**Re: EOLM C&DD Landfill  
Director's Final Findings and Orders (DFFO)  
DFFO  
Construction & Demolition Debris  
Allen County  
CDDL018889**

Re: EOLM-Lima Allen County Landfill, Inc.  
C&DD Landfill  
NWDO Comments on  
EOLM's August 2018 Compliance Plan  
Comment Response Letter

**EOLM-LIMA ALLEN COUNTY LANDFILL, INC.  
COMPLIANCE PLAN**

**CONSTRUCTION AND DEMOLITION  
DEBRIS LANDFILL  
ALLEN COUNTY, OHIO  
FACILITY COMPLIANCE PLAN  
(FINAL DESIGN, SEPTEMBER 2018)**

SCALE:	1" = 50'
SHEET NO.	4
OF	16

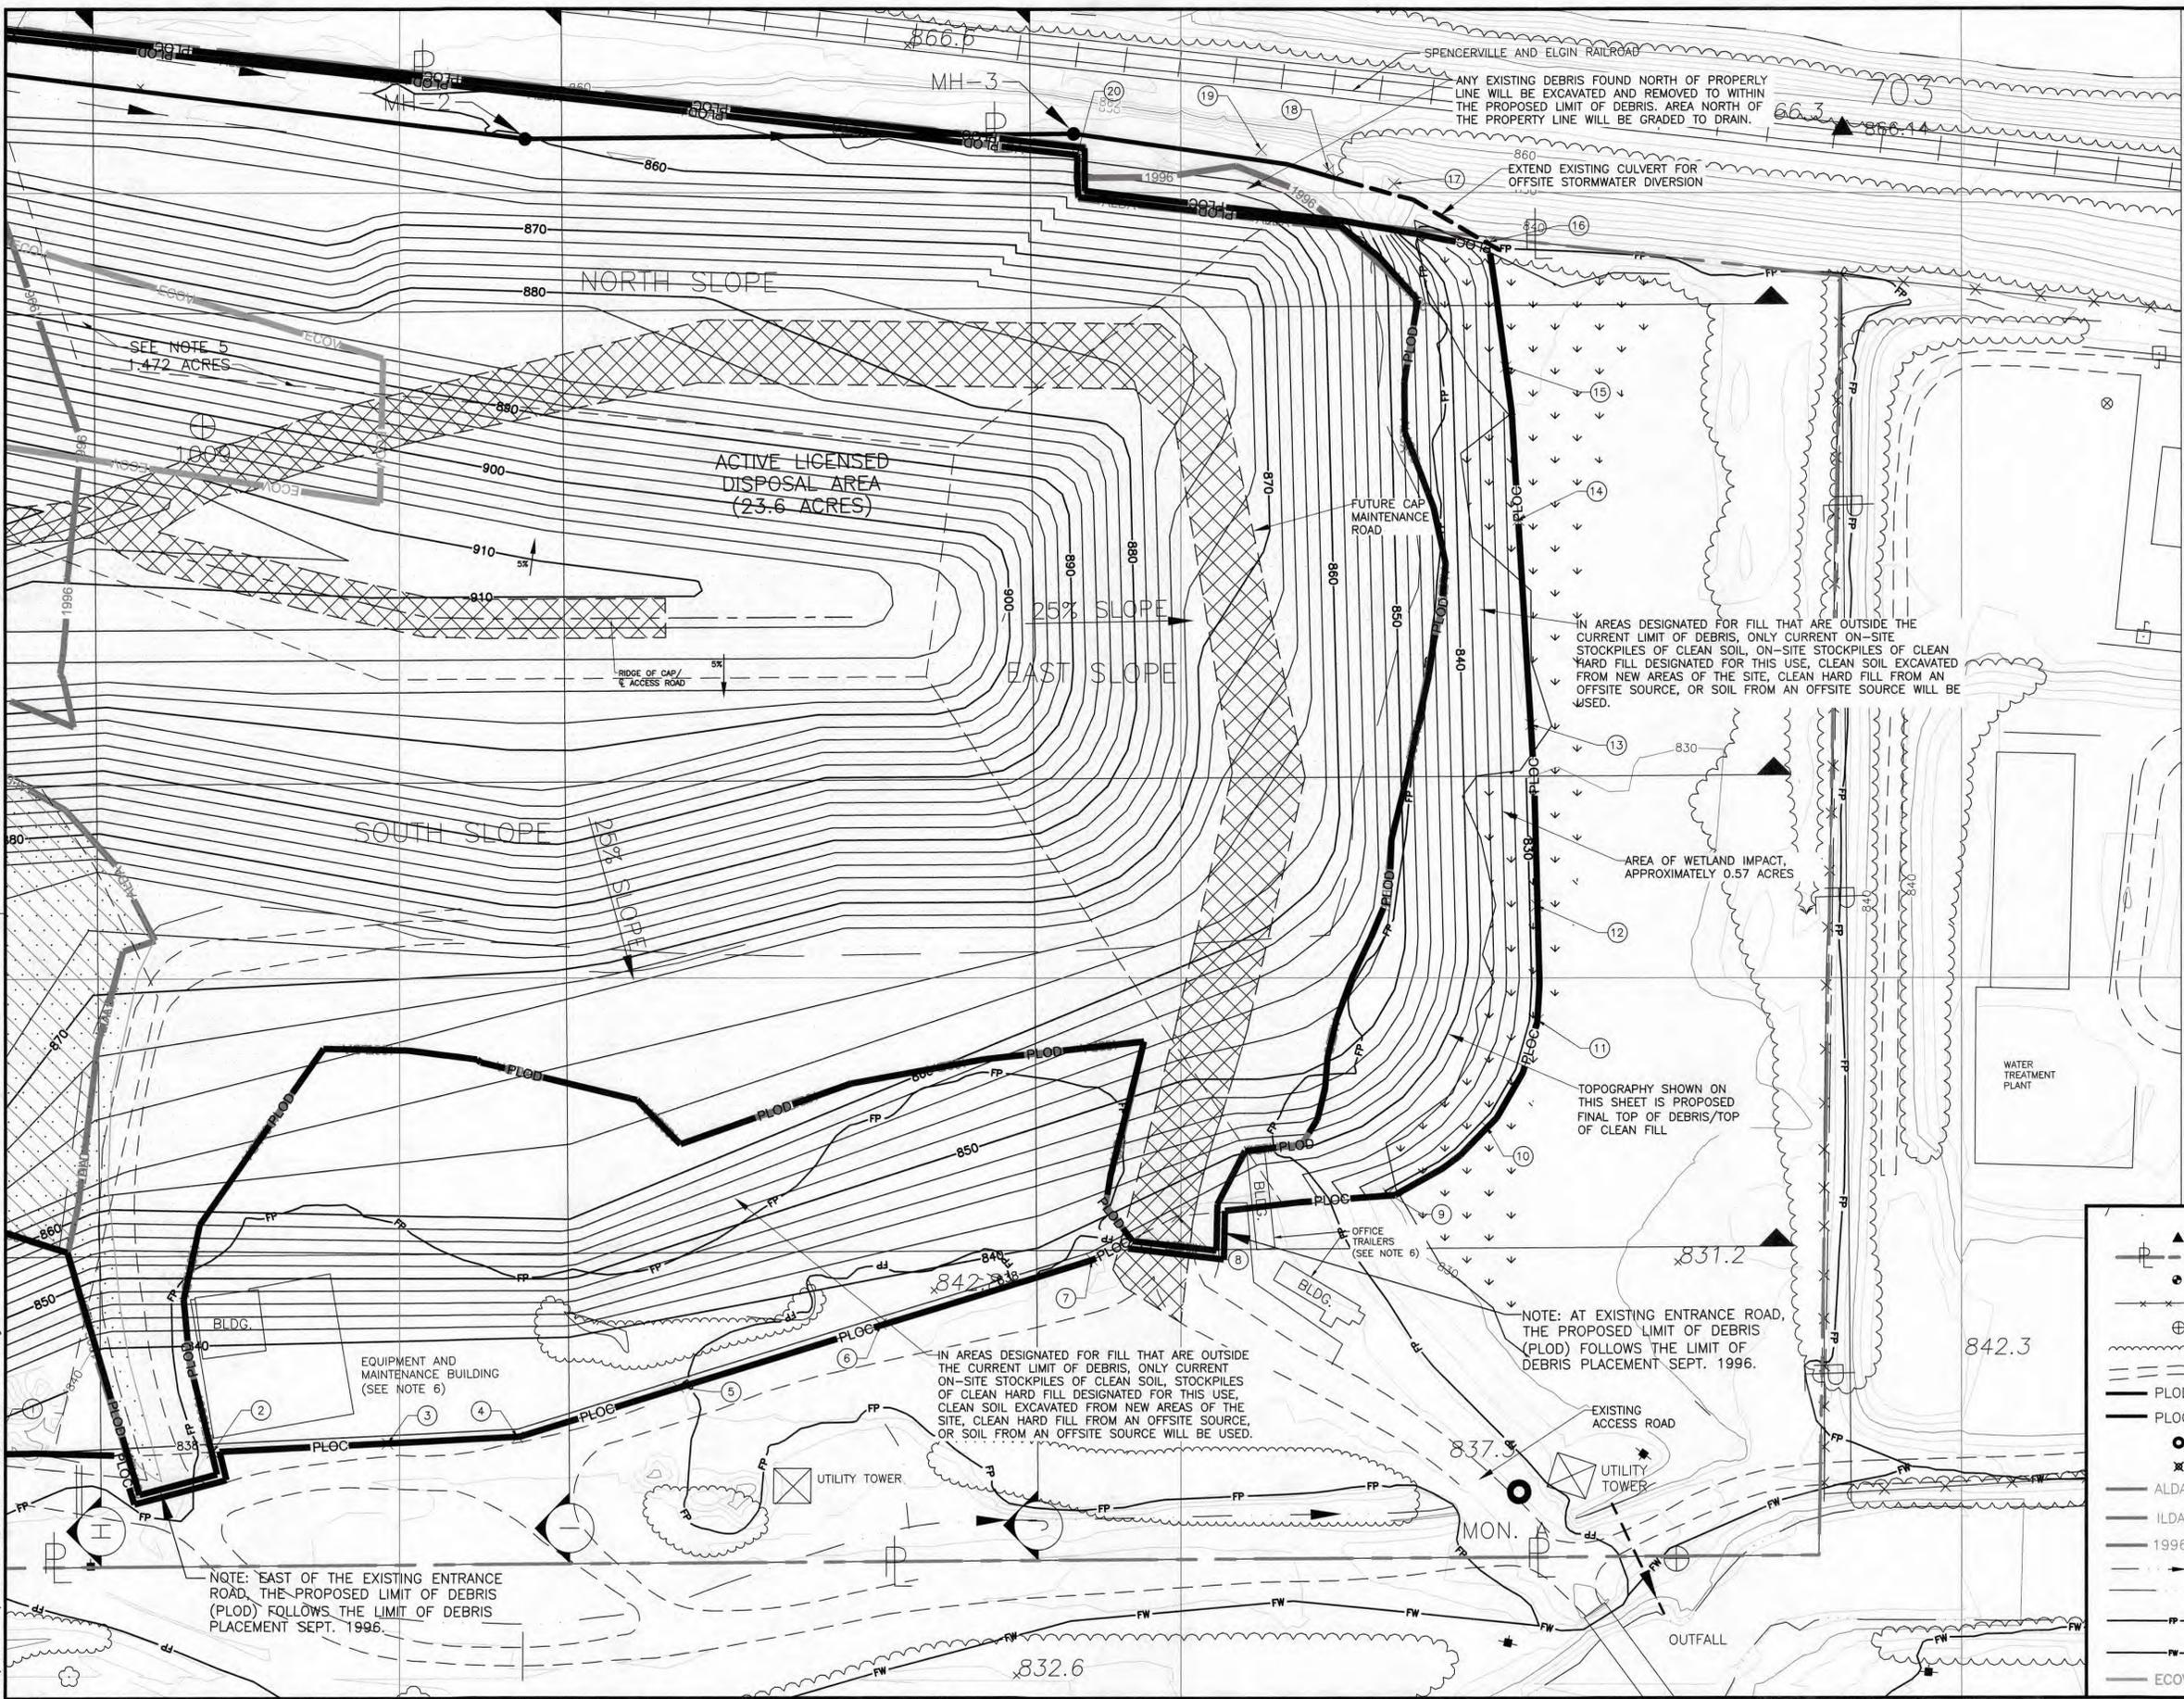
- 4.) *The Authorized and Proposed Limits Plan View Drawing included with the narrative, depicts two areas on the south slope (Southwest Slope, and South Slope). The draft Orders only reference the South Slope. To maintain consistency with the Orders, please revise the drawing to accurately reflect the South Slope area. As part of this revision, please expand the area defined as the “South Slope” so that it includes all portions of the southern slope of the facility that are currently filled above the final grades depicted in the 2016 license. The drawing currently includes an overfilled portion of the facility as part of the Southwest Slope rather than the South Slope.*

**Response:** This item has been discussed with EPA during their recent review of the Compliance Plan. This comment only refers to the drawing included with the narrative. The southwest area was shown on the original submittal for volume calculations. Reference to the southwest slope will be removed. The south slope will only refer to the area where current topography as of September 2015 is above the final grades shown in the 2016 License Application. In order for EOLM to maintain compliance with the Compliance Plan, the limits of the east, south, and north areas of compliance have been added to Sheets 3 and 4.

SCALE:	1" = 100'
SHEET NO.	5
OF	16

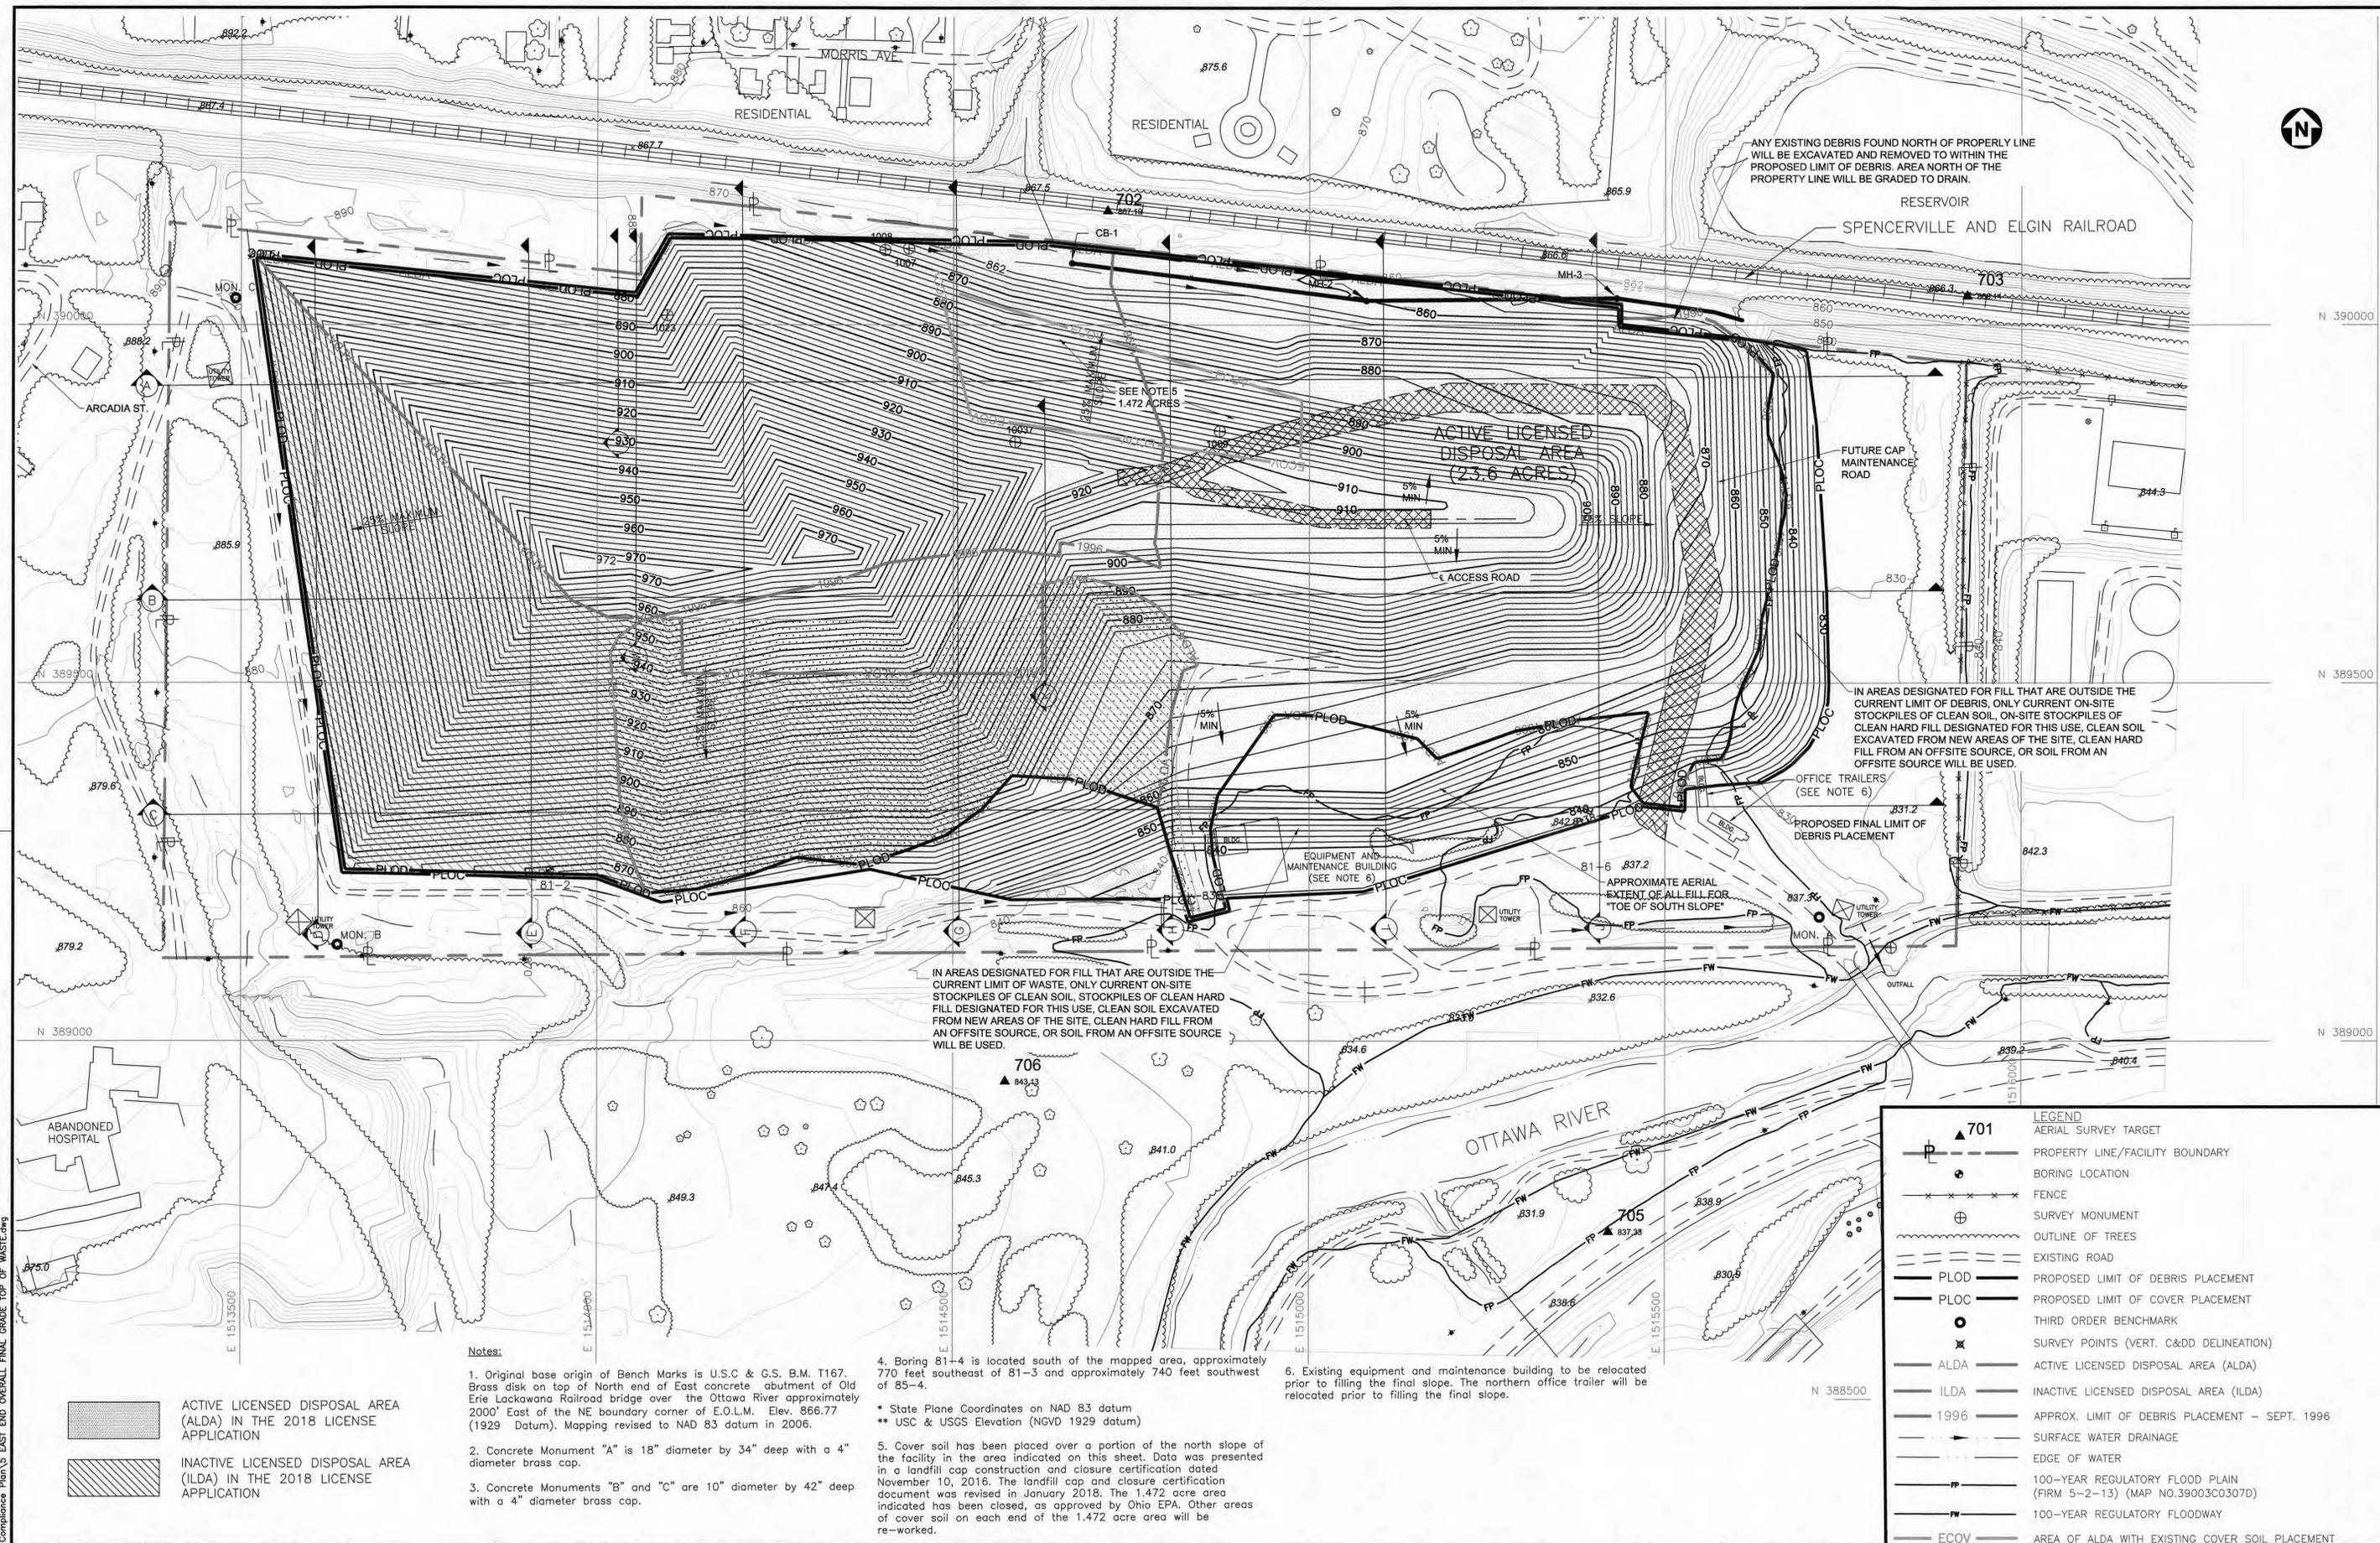
- 7.) *Sheet 5 needs contours of top of C&DD and top of clean hard fill along southern portion of the south slope.*

**Response:** In the area referenced, proposed final debris and clean hard fill contours meet existing grade inside the PLOC, where bold contours meet light contours. For clarity, proposed contours were extended to the PLOC around the perimeter of the landfill.
